R.C.C. TYPICAL FLOOR PLAN
TYPE - B6

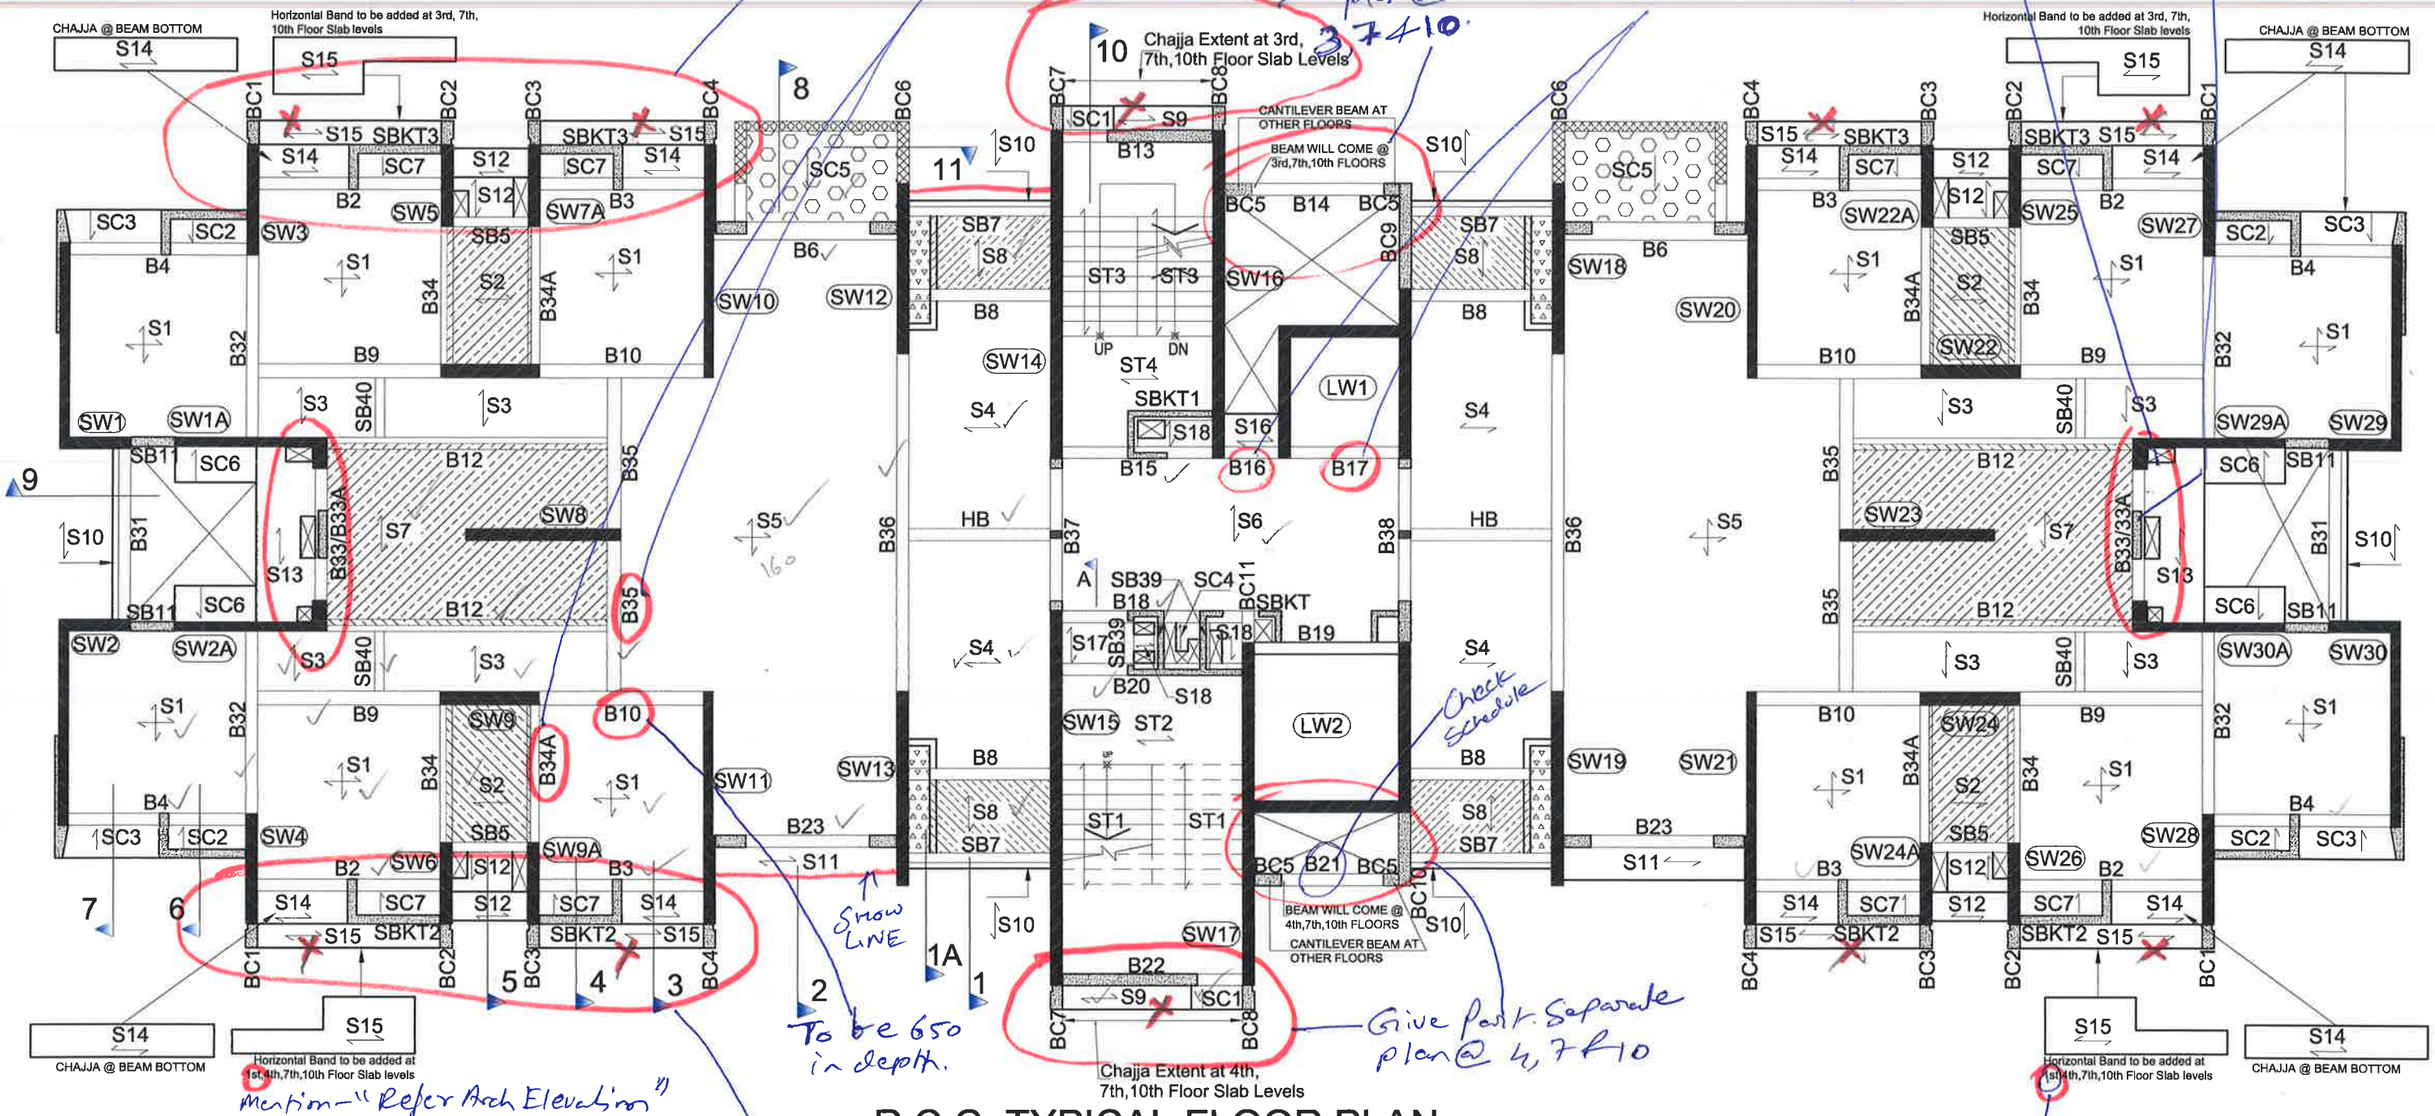
SBKT3 is @ 3,7&10. Give Park. plan.

MENTION "150 mm Drop Pardi" in Remarks not 150 mm THK. ....

MENTION - "Refer Arch Elevation"

Give Park Separate plan @ 3,7&10.

To be 650 deep.

Cutouts to match as on 2nd floor

Non structwall to be same as 2nd floor plan

✗ Remove Lines in main plan.

Give Park plan. SBKT2 is @ 4,7&10.

Remove 1st level already captured in 1st floor plan
